Building Code of Australia 2019

Report for BCA Compliance

PROJECT NAME: The new Sydney Fish Market (SSDA Review Stage)

DATE: 26.09.2019

Figure 4 – Vehicular access for FRNSW

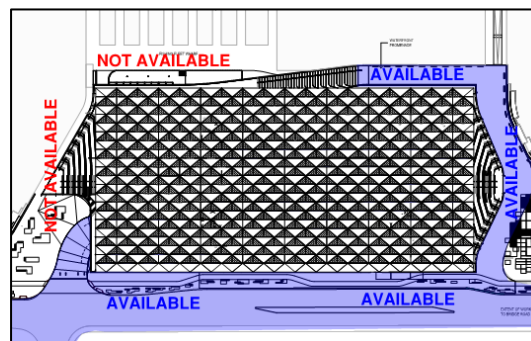
Requirements for open spaces and vehicular access capable of supporting emergency vehicles, 6m wide not more than 18m from the building is required around fire isolated buildings. However, the proposed building is not provided with a continuous vehicular access around the entire perimeter of the building.

Compliance is achievable through a Fire Engineering Performance Solution being prepared by Aecom that will address this matter. This performance solution must also consider Table E2.2 requirement for a perimeter vehicular access.

Figure 6 – Fire-isolated stairs discharge into covered areas

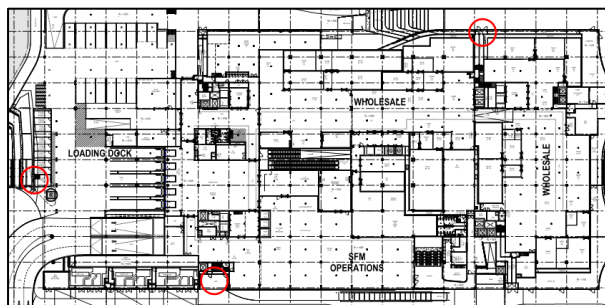
Discharge points into covered areas are found in non-compliance with this clause as no sufficient perimeter or ceiling height is provided. Discharge to a covered area will require:

- Adjoin the road or open space, and
- To be open for at least 1/3 of its perimeter, and
- To have an unobstructed clear height of 3m min.
- To provide unimpeded path of travel to road or open space of 6m max.

Compliance is achievable through a Fire Engineering Performance Solution being prepared by Aecom that will address this matter.

Figure 7 – Interconnected rising and descending stairs in south-western lobby

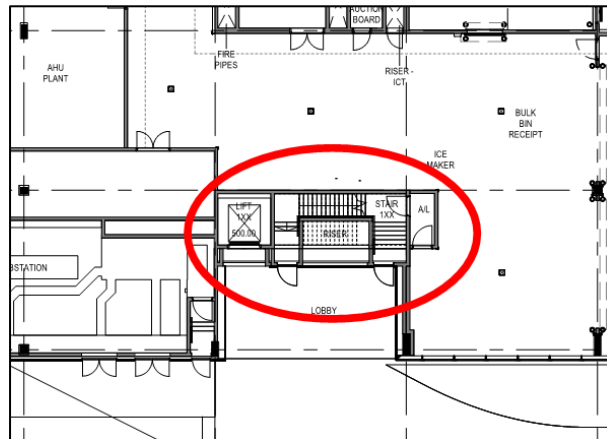
Most of the rising FIS's (from basement carpark) and descending FIS's (from the upper levels) are proposed totally independent and in separate shafts. However, it is understood that the stair adjacent to the south-western lobby will not be in compliance with this clause.

Compliance is achievable through a Fire Engineering Performance Solution being prepared by Aecom that will address this matter.

Figure 8 – Sample of single horizontal exits serving fire rated rooms/spaces

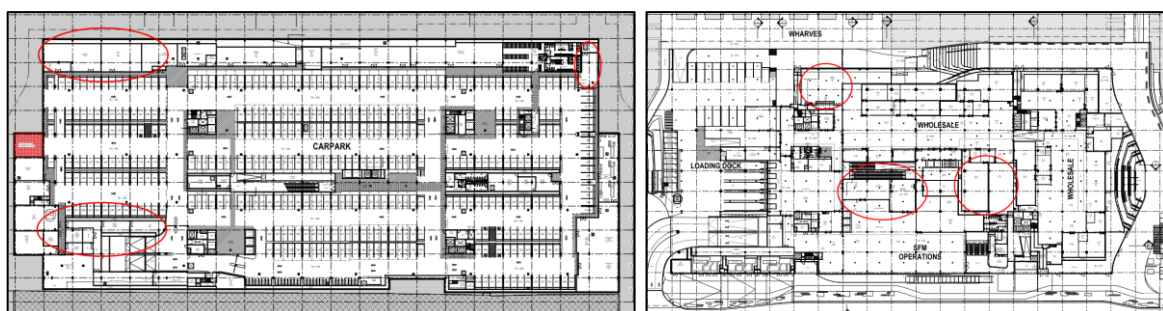
Horizontal exits cannot comprise more than half of the required exit from any part of a storey divided by a fire wall. Fire compartmentalised rooms that rely on a horizontal exit and are not provided with an additional exit (50%) will be non-compliant.

Multiple rooms (i.e. basement, wholesale, etc) are made fire rated (i.e. fire wall) for travel distances and fire compartmentation purposes, therefore required to comply with this clause.

- Horizontal exits must have a clear area on the side of the fire wall to which occupants are evacuating, to accommodate a total number of persons (D1.13) served by the horizontal exits of not less than 0.5m² per person.
- Door swing of the horizontal exits must be in the direction of egress (D2.21) as it is not the only required exit from that part.

Compliance is achievable through a Fire Engineering Performance Solution being prepared by Aecom that will address this matter.

Figure 9 – Plant room connection to open space via lobby

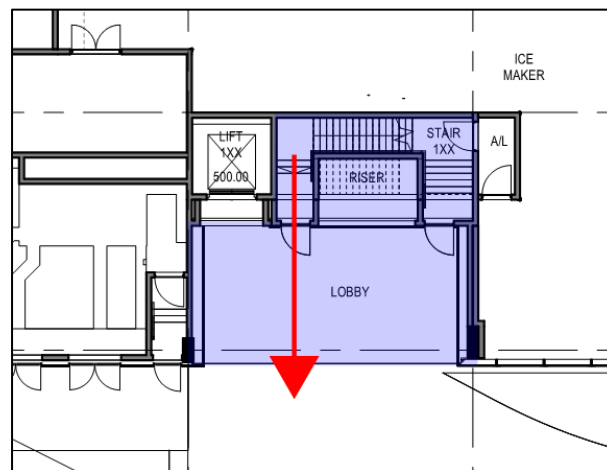
Fire hydrant pump room must be directly connected to open space via a doorway or a fire-isolated passage/stair. The pump room is understood to be located in the F1 Fire Sprinkler & Hydrant Pump Room in basement (grid B 5-8 approx.) and served by a fire-isolated stair, however connected to an external building lobby in lieu of open space in non-compliance with this clause.

Compliance is achievable through a Fire Engineering Performance Solution being prepared by Aecom that will address this matter.

Figure 10 – Plant room connection to open space via lobby

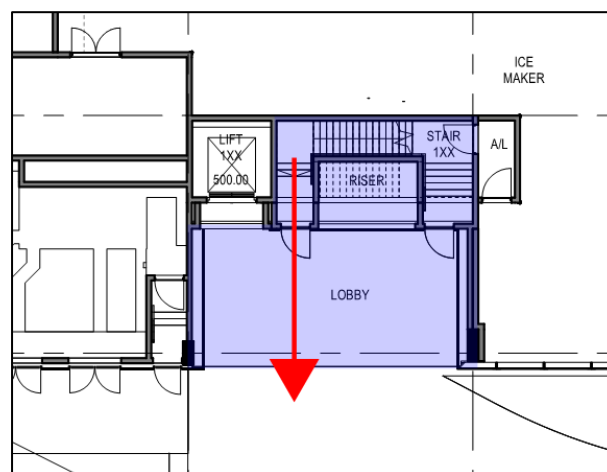
Sprinkler alarm valves must be located in a secure room which has direct egress to a road or open space. The sprinkler alarm valve is understood to be located in the F1 Fire Sprinkler & Hydrant Pump Room in basement (grid B 5-8 approx.) and served by a fire-isolated stair which discharges out to an external lobby. This is a non-compliance as the external lobby is not an “open space” as defined by the BCA.

Compliance is achievable through a Fire Engineering Performance Solution being prepared by Aecom that will address this matter.

Figure 11 – Auction Hall location

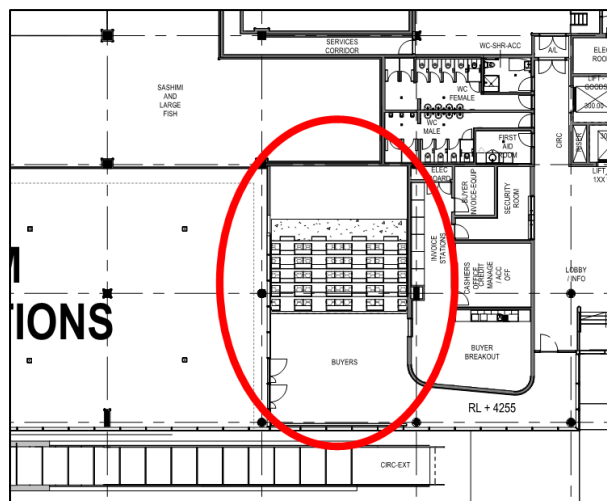
The proposed Auction Hall is currently connecting more than 3 storeys therefore the provisions from this clause are applicable. No fire-resistant bounding construction, smoke hazard management, fire-fighting equipment, etc. are identified at this stage thus in non-compliance with this clause.

Compliance is achievable through a Fire Engineering Performance Solution being prepared by Aecom that will address this matter.
